Courtyard enclosure study · closing the conditioned house around the open courtyard · Taif / Palm House V7.1

Design review Y-01 (critical) · 30 Oct 2026 · the windows follow `docs/DESIGN_LANGUAGE.md` (black steel, divided lites)

DECIDED: option A (owner, 30 Oct 2026, applied in V7.0): the projection 1.55 m, B3 / R11 / C21–C23 at x 5.80, W1 / W2 / W3 as in § 2. The "now" column below is the V6.3 state (edge x 5.60), kept as the record of the comparison.

Plans of the gallery strip, first floor · now / A / B · the sky opening and the void · about 1:115 on A4

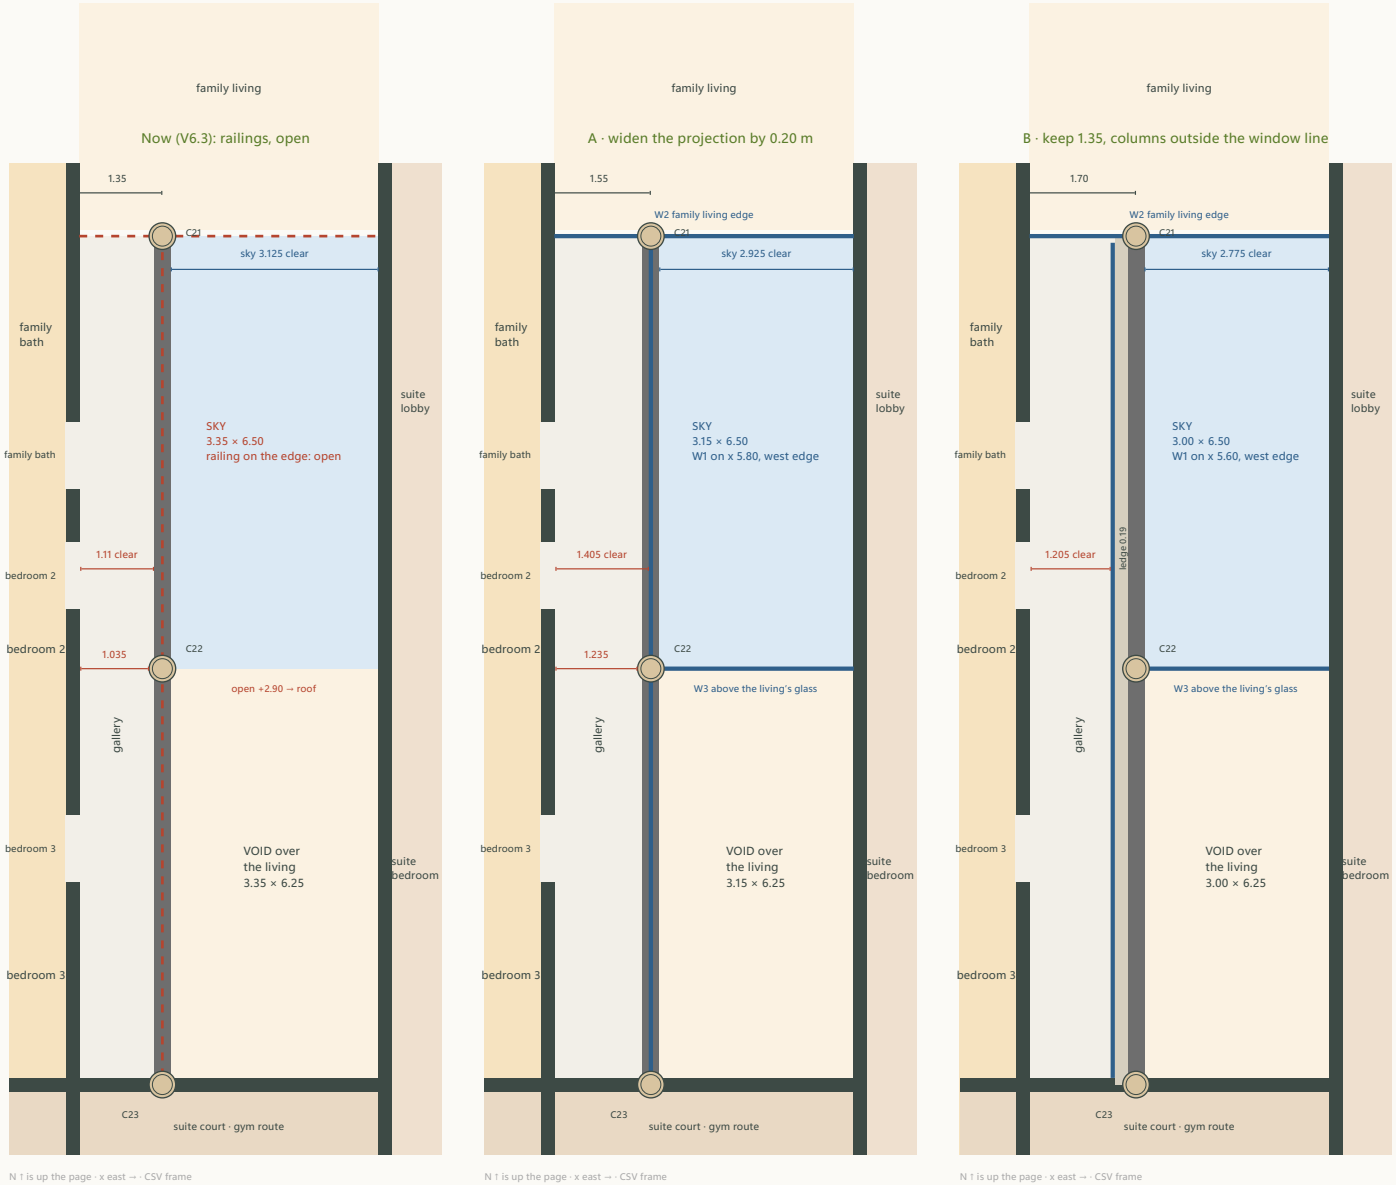
Today the gallery is 1.11 m clear between the rooms' finished wall face (x 4.365) and the upstand of B3, and 1.035 m at the three stone column sleeves (Ø0.4). A window on the line changes little by itself; the columns are the problem. Two ways to reach 1.20 m:

Dark: walls and the edge beam B3 (0.25 wide, upturned 0.30 above the slab). Blue lines: the new steel windows W1 / W2 / W3; red dashed: the open railings of today. Columns: the stone sleeve Ø0.4 round the Ø0.3 core. In B the beam and the columns leave the window line and a 0.19 m ledge lies between the glass and the beam (capped in stone, falling to the courtyard). The gallery doors are the V6.3 1.00 m openings.

4 · Recommendation: A **A** keeps everything on one line: the beam, the columns, the window and the railing base are the same element, the gallery is 1.405 m clear and 1.235 m at the columns, the sky loses 6 % of its area and stays 3.15 m wide on axes. **B** reaches 1.20 m with no margin (1.205 m), narrows the sky more (3 m: the beam and the roof edge must follow the columns), and adds a 0.35 m ledge outside the glass that must be waterproofed, capped and kept clean; its one real gain, free-standing columns in front of a glass wall, is a stronger colonnade image. If the owner wants that image, B is buildable; otherwise A. In both, the two-storey columns, the upturned B3 and R11 stay as decided (X8); only their x changes. **Study checks passed** (7)

Sections through the courtyard (y ≈ 10, looking north) · A and B · about 1:105 on A4

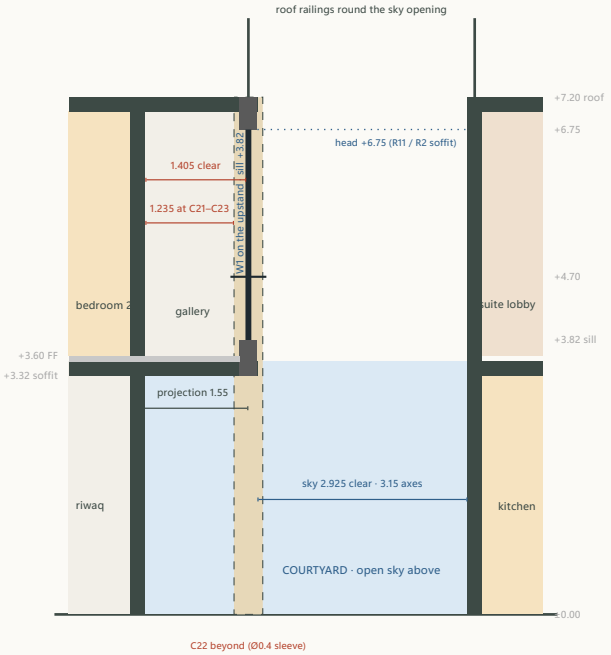
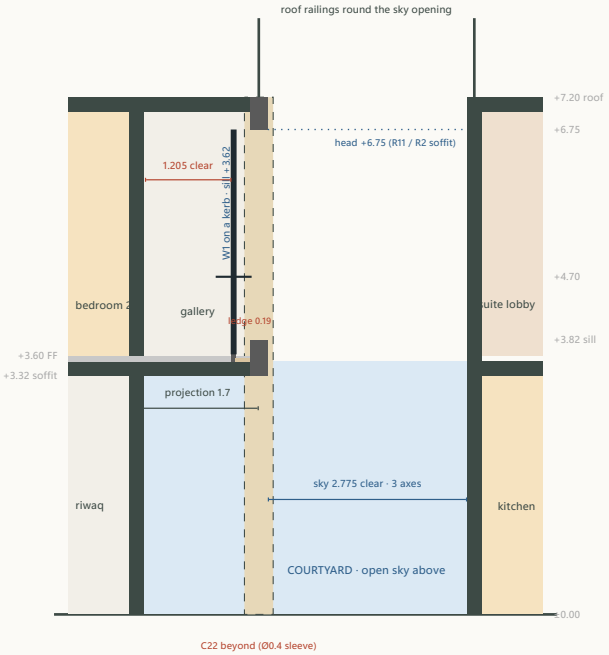
Dark: walls, slabs, the roof; grey: the upturned edge beam B3 (0.25 × 0.50 total, 0.30 above the slab) and the roof edge beam R11 above it; the dashed column is C22 (y 13.0) beyond the cut. W1 (heavy black line) sits on the upstand (A) or on a 0.10 m kerb inboard of it with a stone-capped ledge outside (B); its guarding transom at +4.70, its head at +6.75 under R11.

Both options. W1 bears on the upstand of B3 (the window's dead load is small; the upstand becomes its sill and its anchor, 0.25 wide); W2 on B2 (floor-level sill, the frame anchored to the slab edge and R1); W3 spans +2.90 → +6.75 between C22 and the kitchen wall, held top and bottom (R2 above; a steel transom at +3.82 tied to C22 and the wall takes the wind of the 3.85 m height; the courtyard well has little wind). The head line is the soffit of R1 / R2 / R11 at +6.75 over the void (y 13–19.25) a 0.25 m fascia keeps the same line under the roof slab. Nothing new for the engineer except the window anchors and, in B, the ledge.

- **A:** B3, R11 and C21–C23 move 0.20 m east to x 5.8 the projection slab bay becomes 1.55 m (slabs-ff row "the projection"), the roof strip over the gallery 1.55 m (slabs-roof); C22 stays the pier in the living's courtyard glass (now at x 5.8), C21 in the women's majlis glass, C23 in the living's south wall; the spans (6.5 / 6.25) are unchanged, R2's west end lands on C22 at x 5.8. The sky opening is 3.15 × 6.5 m.

- **B:** B3, R11 and C21–C23 move 0.35 m east to x 5.95 the slab bay becomes 1.7 m with the window line 0.35 m inboard of the beam on a 0.10 m kerb; the ledge between the kerb and the upstand is waterproofed and capped (stone, falling out). The columns stand free in the courtyard and in the void: C22 is a free column in the living's courtyard glass line, 0.35 m in front of the upper window W3 (W3 then runs behind it, from the W1 line at x 5.6 to the kitchen wall, 3.25 m). Alternative B2 (not recommended): B3 stays at x 5.6 and reaches the columns at x 5.95 on short corbels; two lines of concrete for one edge.

W1 · the gallery line seen from the courtyard and the void (looking west) · option A · 1:70 on A4

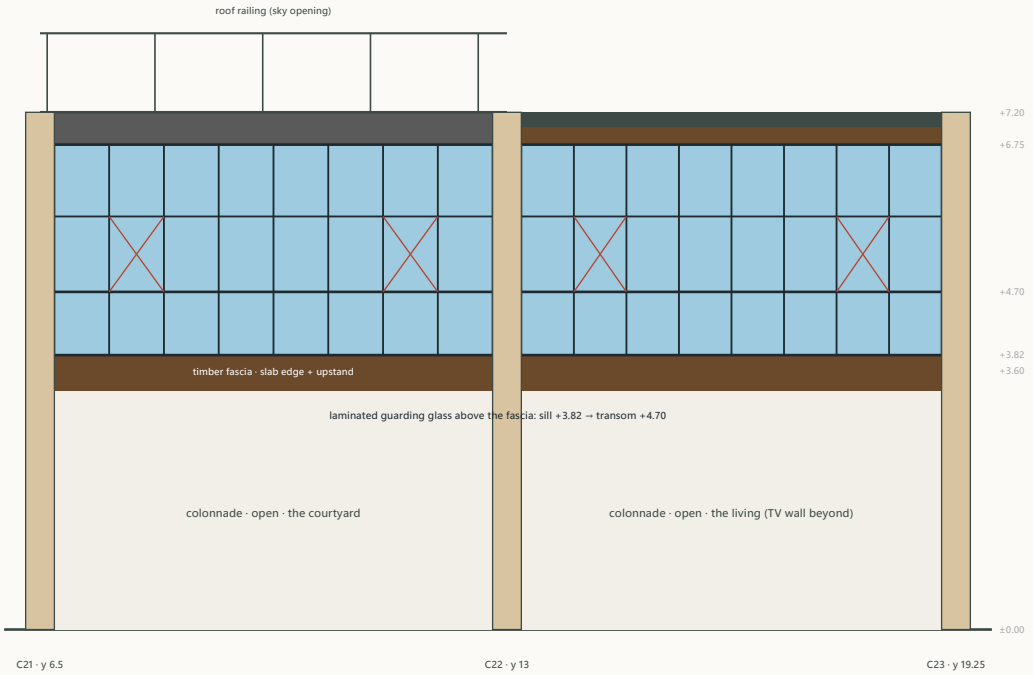
V7.1 (owner, 31 Oct 2026): semicircular heads and the courtyard arcade. Every enclosure window gets a semicircular (Roman) arched head in black steel with divided lites, the arched head fixed, the rectangular part below with the operable lites; the sill and the guarding transom (+4.70) as in § 2. **W1:** six arched windows 1.60 m wide on the gallery edge, three per column bay, sill +3.82, springing +5.80, crown +6.60, 0.15 m of wall below the R11 / R2 soffit (+6.75): in the courtyard bay they stand over the three bays of the new arcade (y 6.783–8.383, 8.950–10.550, 11.117–12.717), in the void bay on three equal bays (13.242–14.842, 15.325–16.925, 17.408–19.008); the four casements sit in the lower parts. **W2:** two arched windows 1.30 m wide east of C21 (x 6.00–7.30 and 7.55–8.85), floor to the crown +6.60, springing +5.95; the strip x 4.25–5.80 of that edge is the family living's opening to the gallery's north end, no window. **W3:** one arched window 2.80 m wide (the whole space between C22's stone sleeve and the east wall; the brief said ≈ 3.0) over the living's courtyard glass, +3.32 to the crown +6.60, springing +5.20, the two motorised tilt lites in its lower part; 0.15 m of wall to the R2 soffit. **The arcade:** in the courtyard bay only, two slender honey-stone columns Ø0.25 on x 5.80 at y 8.667 and 10.833 (three equal bays of 2.167 m on axes) with three semicircular arch plates under the projection's soffit (+3.27): spans 1.84 / 1.92 / 1.84 m between the sleeves, springing +2.35 / +2.31 / +2.35, crown +3.27; decorative unless the engineer uses the columns (`studies/structure.typ` X18); the living bay keeps no arches. The columns stand 0.78 m clear of the sunken seating's west edge, 1.36 m clear of the riwaq door's swing line, 1.33 m from the riwaq glass face; the malqaf outlet is on the east wall. The courtyard reads as a two-tier arcade: three arches below, three arched windows above.

black steel, divided lites ≈ 0.75 wide · transoms at +4.70 (guarding) and +5.75 · red X = inward side-hung casements, two per bay (night mode, cleaning) · about 35.01 m² of glass · A · widen the projection by 0.20 m
